ADDENDUM NUMBER 1
TO THE DRAWINGS AND SPECIFICATIONS

PROJECT: Lincoln Adams Elementary School 2023 Reroof

A/E PROJECT NO: 26351422

APPENDUM 1 ITEM 3

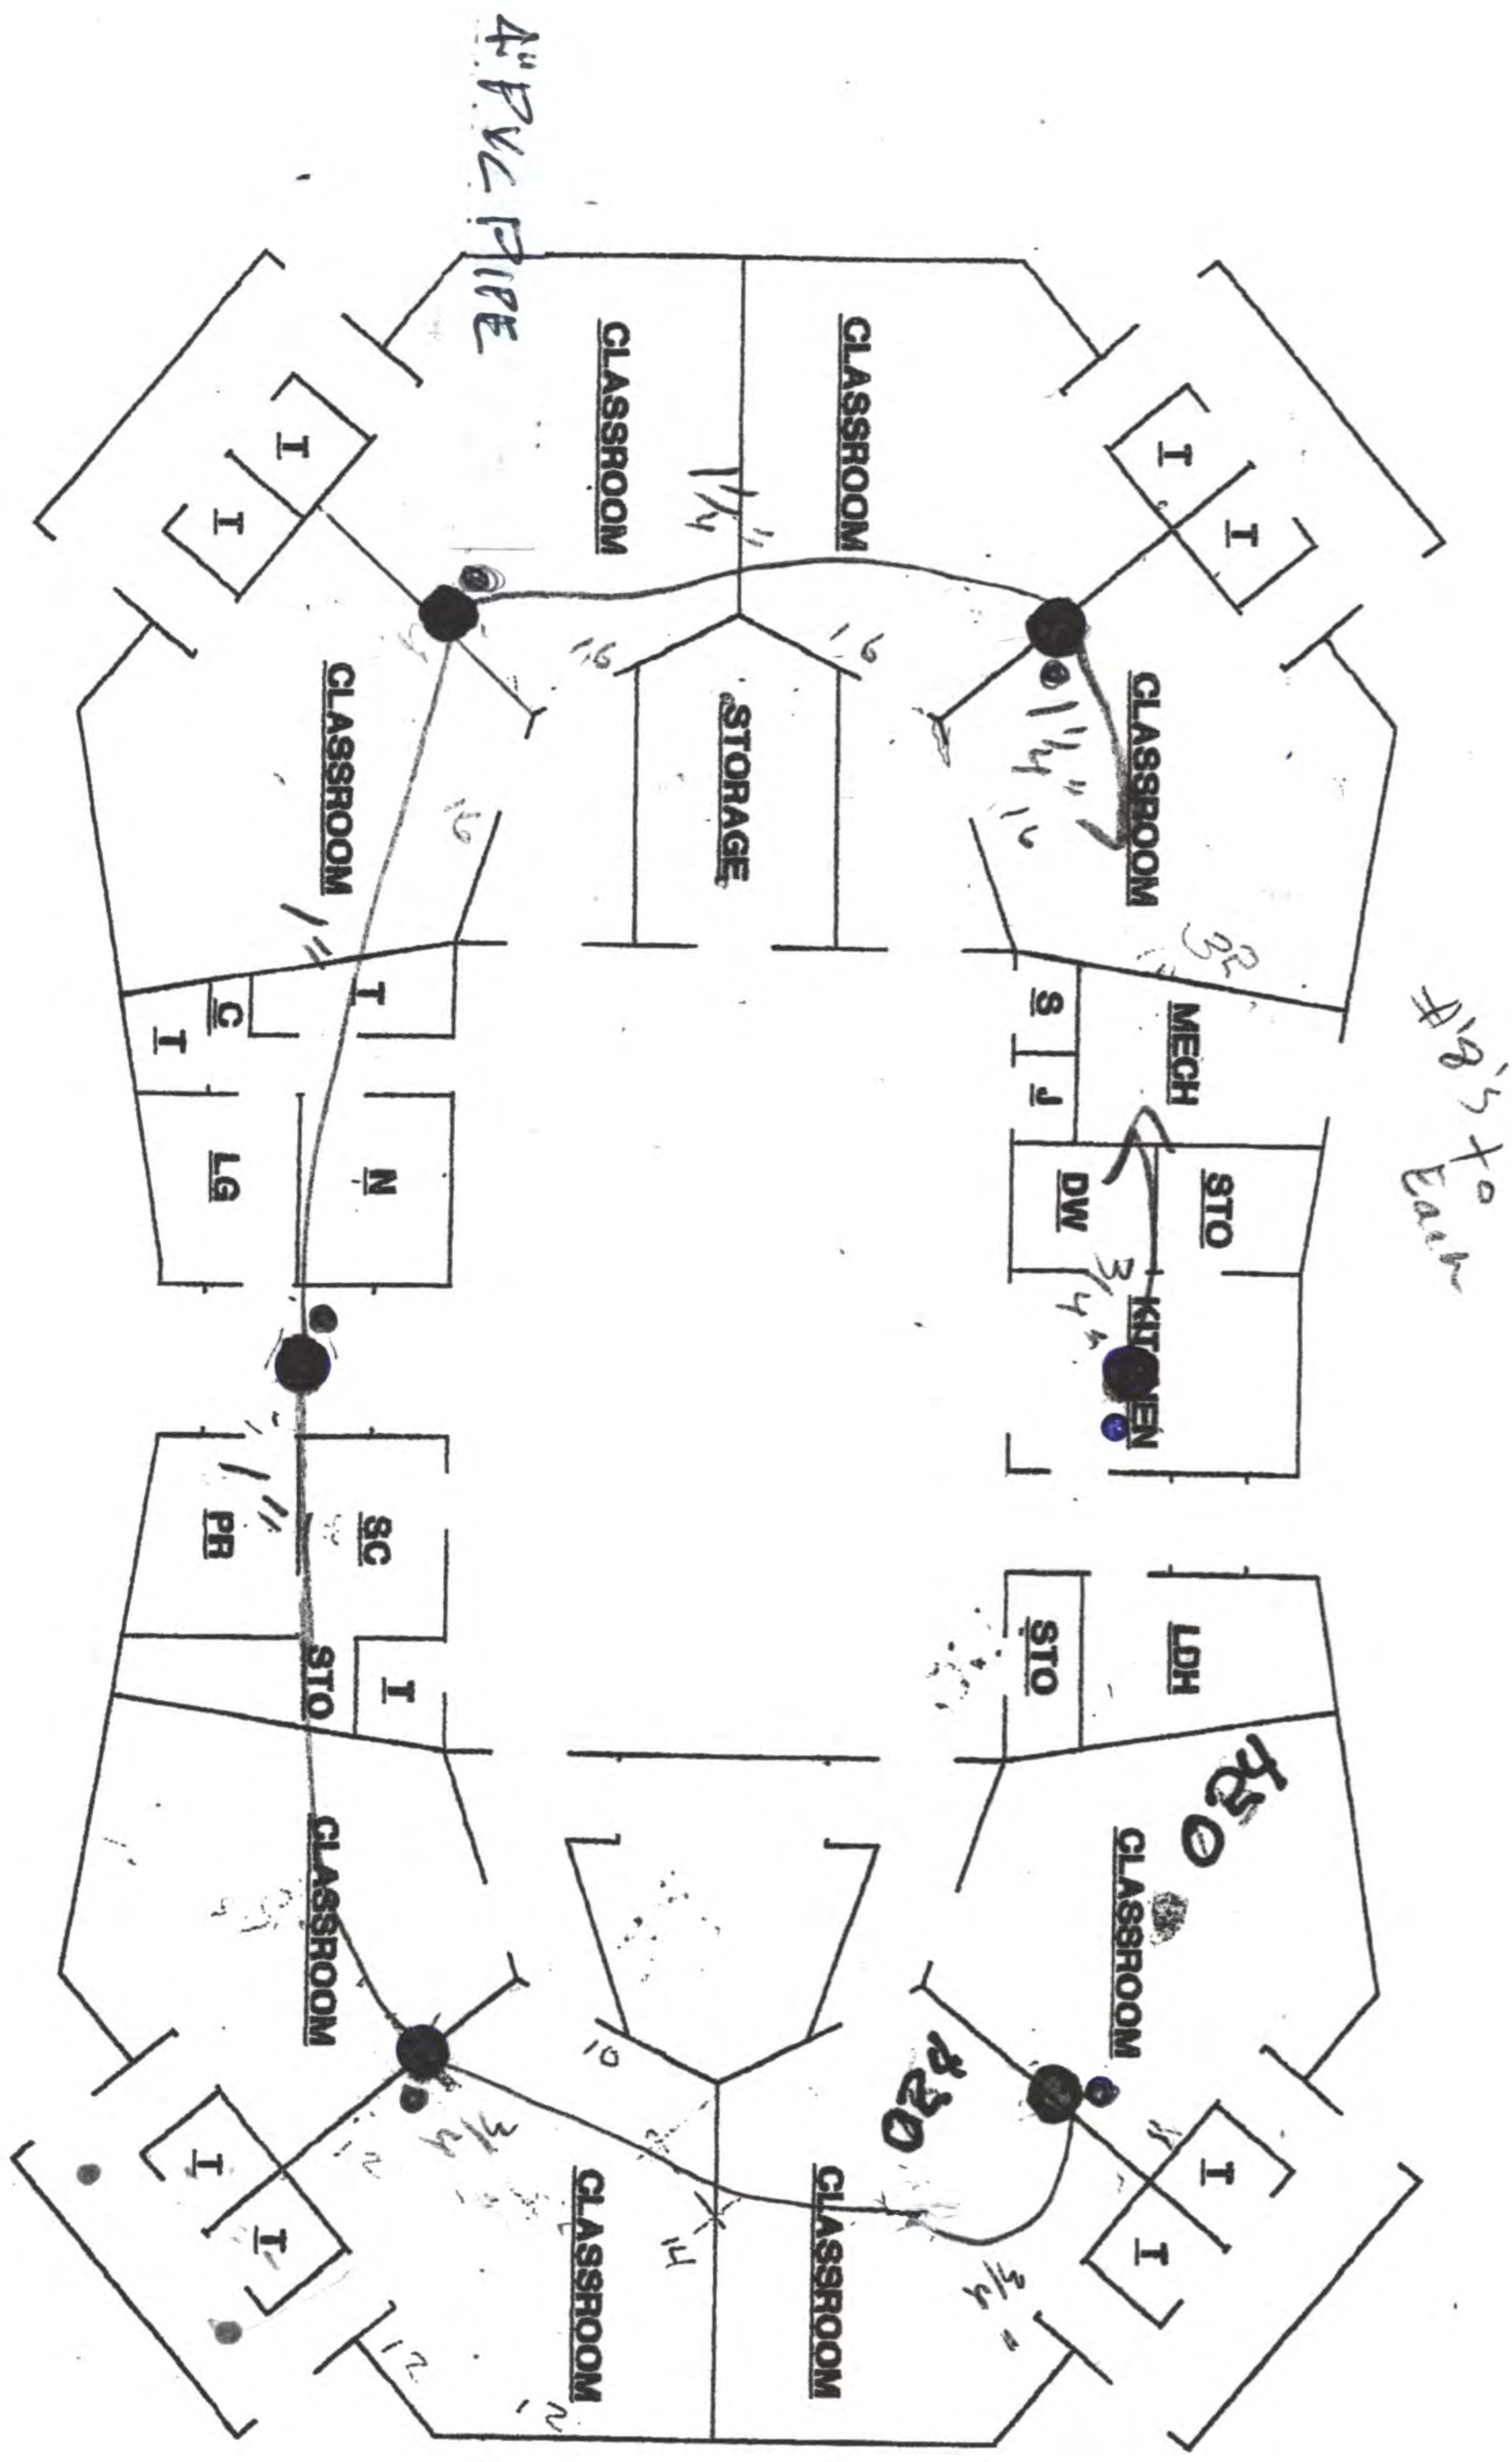
3. TO THE DRAWINGS; Sheet No. A301: The District No. 27 has accepted a bid from Lincoln Cooling & Heating (phone: 217-735-5825) to place six (6) RTU's on the roof as indicated on attached plan. The RTU's will be set on a pad 16" x 54" provided and installed on the new 60 mil roof – all work done by Lincoln Heating & Cooling. The only work added to this reroof scope of work will be six (6) 4" holes cut through the new installed roof, the existing BUR roof, and the existing lt. wt. concrete 1" deck. Lincoln Heating & Cooling will install a 4" PVC pipe hooked on top to prevent water penetration. This pipe will provide the only connection for the exterior heat exchanger and the interior fan and ductwork. The roofing contractor will provide and install a EPDM pipe flashing as shown in Detail 2, Sheet A 301, on all 6 units.
